Ashbourne – Applicant Response to s70 Comments

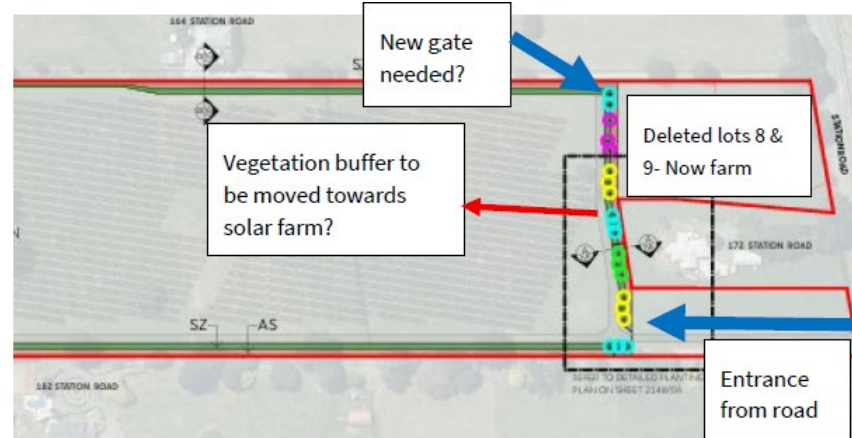
| Condition/Paragraph | Section 92 Item | Action / Response |
|---|---|--|
| 1. | <p>The entrance way to the deleted lots 8 & 9 is still in the diagram on page 14 and 17 (see below). Can this please be confirmed if this is still here. I understand that only one this entrance is allowed on this farm lot 2 DP 567678.</p>  | We confirm that this is an error, and no access is proposed in this location. |
| 2. | <p>If this gate /access is not allowed, how will the solar farm have access to the area that was originally lots 8 &9? The vegetation buffer goes up to the boundary of our section (lot 1)-see below. How are the stock going to have access to that bit of land? Will they have to put another gate from the solar panels to this area? Or will they need to push back the vegetation buffer towards the solar farm to provide an access road at the end of our property? I request that this be confirmed.</p> | We propose to create a 3m wide opening in the buffer planting and integrate a manual gate to provide access. |

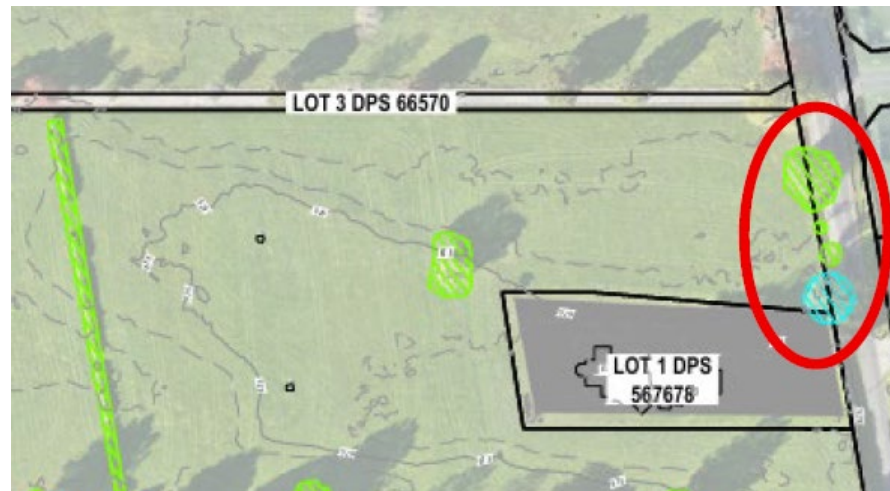
I also query why the developers (see diagram below) state on page 2 and 5 of the same document that they are still removing the trees along the roadside of Station Road. Can this be confirmed as well.

We confirm that with the proposed access point no longer being required for the rural residential lots, the existing vegetation highlighted in the red circle will no longer be removed or trimmed.

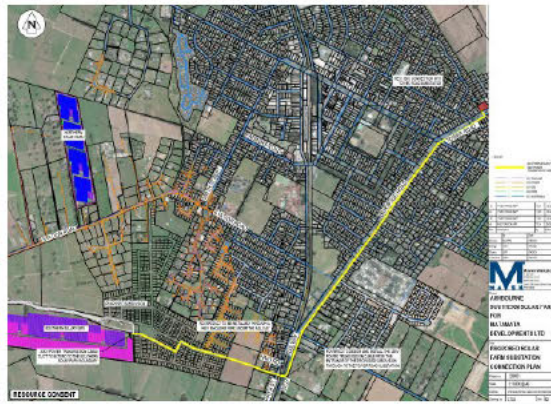
| Condition/Paragraph | Content | Action / Response |
|-----------------------------------|--|--|
| 4 | In paragraph 11 of A2 MPDC SUB which states that the northern solar farm must be operational before Stage 4 of the residential development commences. This includes the 33KV power transmission cable connection from the northern solar farm to the Tower Road Sub Station (confirmed with As Built plans). Can this please be checked as the Maven designs (Maven Plan “Proposed [Northern] Solar Farm Connection Plan: (Ref: C720, Rev B, dated May 2025)) state that the power is going via an 11 KV power transmission line to Brown Street. | Correct – the wording of this condition will need to be amended. |

It is the southern Solar farm that is being taken through to the Tower Road Substation (Maven Plan “Proposed [Southern] Solar Farm Connection Plan: (Ref: C720, Rev D, dated May 2025)) see below

Highlighted in Purple line where the Waikato Regional Council Board drain in question runs.

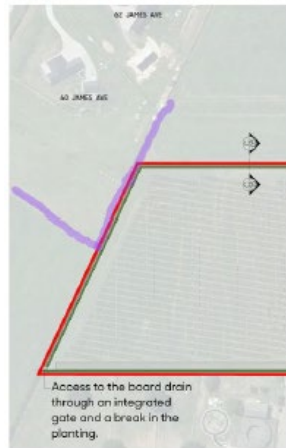
I emailed the panel on 26/11/25, indicating that the gateway and break in the planting are on the North Western corner of the property. I indicated in my email the path of the drain by highlighting it in purple. See below.

My email stated “This showed that there is still no access to the WRC drain due to the fence and planting.

Access to the board drain will be maintained if applicable. Note that we have confirmed with WRC outside of this process that there are no WRC-managed drains within the site boundaries.

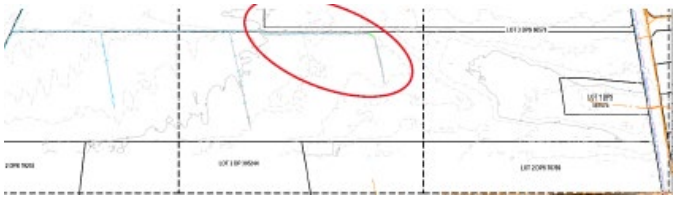
On page 10 of 44 Ashbourne Northern Solar Farm for Matamata Developments Ltd – Proposed Contours Key Plan C210 Rev E, the gateway has been replaced by a vehicle turnaround.

There is no access at all to the drain for cleaning as requested by WRC.

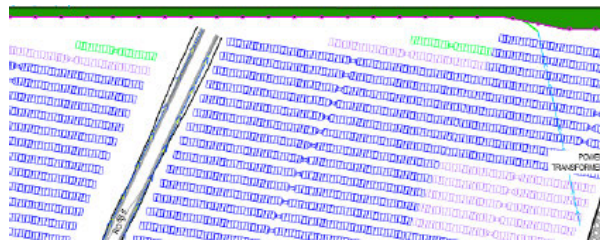
| <p>9</p> | <p>Furthermore, in the same document, there is a farm drain that crosses the boundary from the Eastern boundary of the Northern Solar farm onto 164 Station Road. (see below) from page 6 of 44 Ashbourne Northern Solar farm for Matamata Developments Ltd – Existing Contours Key Plan C200 Rev B</p>  <p>There is a visible open farm drain on the Northern Solar Farm, see below.</p> | <p>As above.</p> |

On page 12 of 44 the drain is covered by 3m of buffer planting and the 2.2 m high security fence which indicates that the drain will be inside the buffer planting zone before the drain goes across the fence to Lot 3 DPS 66570.

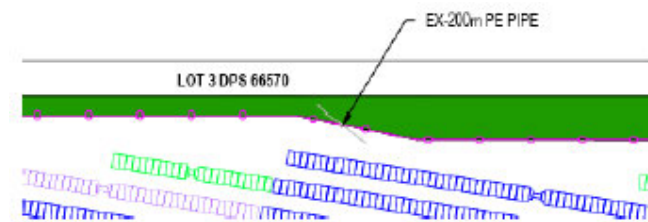
Further evidence of the drain being inside the buffer planting and therefore not accessible for cleaning and maintenance is on page 26 of 44 Ashbourne Northern Solar Farm for Matamata Developments Ltd – Proposed Roding plan sheet 2 of 3 C300-2 Rev F.

(Page 40 of 44 in the document Ashbourne Northern Solar Farm for Matamata Developments Ltd – Proposed Services Key Plan C700 Rev E)

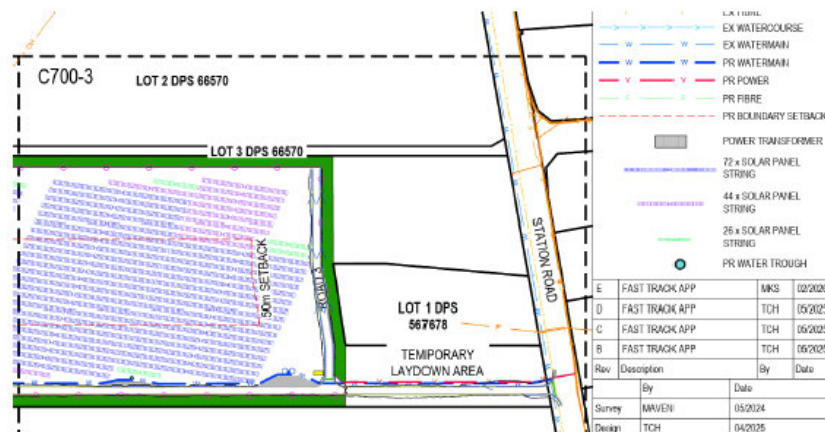
On the latest Engineering Drawings for the Northern Solar Farm, there is an indication that a town water connection will be installed for the firefighting water supply and for the troughs for the animals that will be grazed on the solar farm.

this is likely connected to the existing 25mm MDPE ridermain that runs parallel with the development site. The existing water supply will be potholed to confirm. The water supply required for the tanks and water troughs, will only require a trickle feed to top them up periodically and it will have a low water demand similar to the current arrangement. There are no known bore water supply points identified within the site.

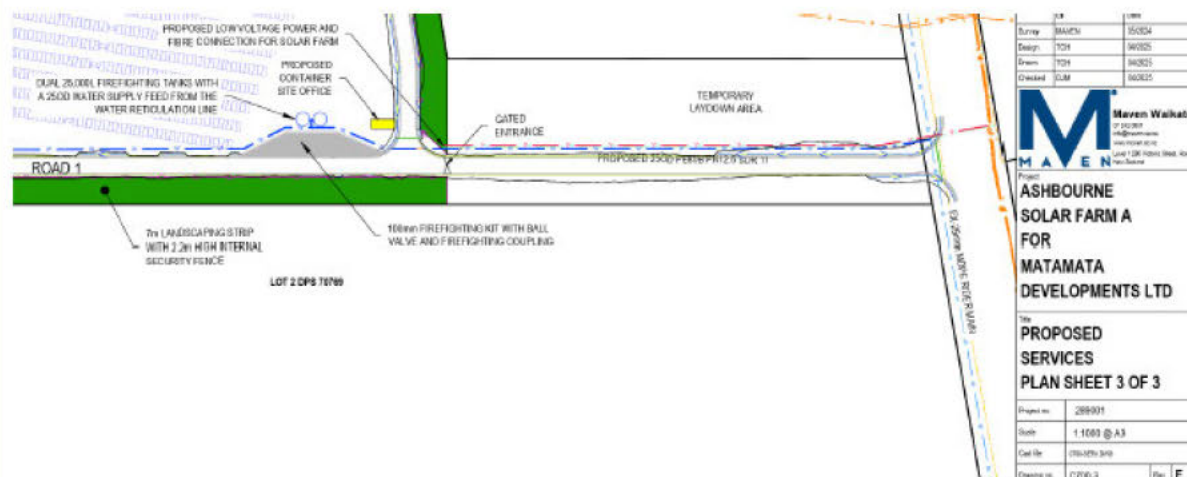
And evidence that the Applicant is still proposing to connect to the town water supply for water for animals is on Ashbourne Solar Farm A for Matamata Developments Ltd – Proposed Services Plan Sheet 3 of 3 C700-3 Rev E

The applicant proposes to connect to the EX-25mm MDPE Rider Main using a Proposed 250D PE80B PN12.5 SDR 11 pipe/hose.

Page 17 of 44 Document Ashbourne Northern Solar Farm for Matamata Developments Ltd – Proposed Cut/Fill Key Plan Sheet 3 of 3 C220-3 Rev E shows a very clear area of fill required for what looks like a driveway.

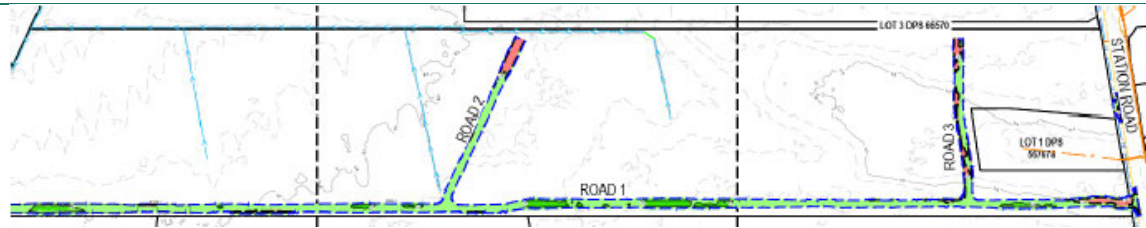
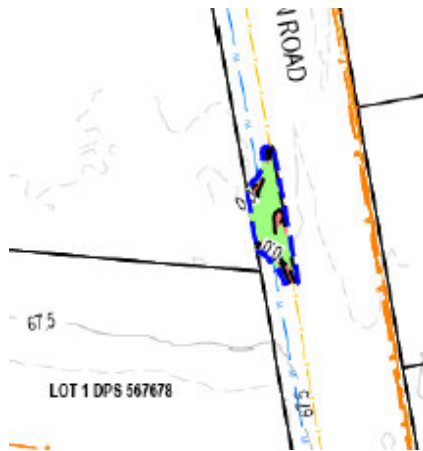
| 12 | <p>On page 14 of the document, Ashbourne Northern Solar Farm for Matamata Developments Ltd – Proposed Cut/Fill Key Plan C220 Rev E, there is an area of proposed cut where the driveways for the proposed, then cancelled, Lots 8 and 9 were located.</p> | As noted above, this vehicle crossing is no longer proposed. |

Why is there a need to have this detailed on the Plan for cut and fill if the subdivision of lots 8 & 9 is not going to occur?
